# United States Patent and Trademark Office

APPLICATION NO.	FILING DATE	FIRST NAMED INVENTOR	ATTORNEY DOCKET NO.	CONFIRMATION NO.	
10/697,711	10/30/2003	Brieanna Herrick	2864.HERR.PT	8362	
26986	7590 08/09/2006		EXAMINER		
MORRISS O'BRYANT COMPAGNI, P.C.			LOPEZ, AMADEUS SEBASTIAN		
136 SOUTH MAIN STREET SUITE 700		ART UNIT	PAPER NUMBER		
	SALT LAKE CITY, UT 84101				
			DATE MAIL ED: 08/09/200	DATE MAILED: 08/09/2006

#### **DETAILED ACTION**

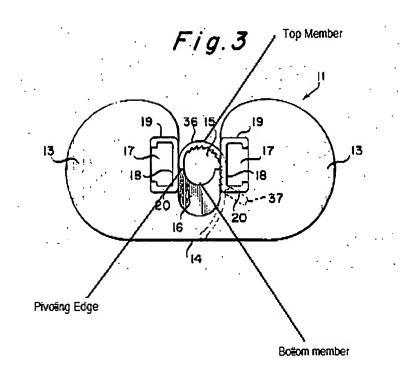
23. With regards to claim 2, what is taught and shown by White et al in figures 1-3 and the figure below is an endotracheal tube holder wherein the endotracheal tube holder member further comprises: a bottom member generally formed as half a cylinder cut lengthwise (16; Fig. 3) which includes a first semicircular depression along a long axis for receiving the endotracheal tube; and a top member (formed by piece 36; Fig. 3) generally formed as half a cylinder cut lengthwise, which includes a second semicircular depression for receiving the endotracheal tube, wherein the bottom member is coupled to the top member along a pivoting edge (labeled below) which is parallel to the lengthwise axis, such that the bottom member and the top member form a cylinder with a hole (15) formed from the first and second semicircular depressions through the center thereof.
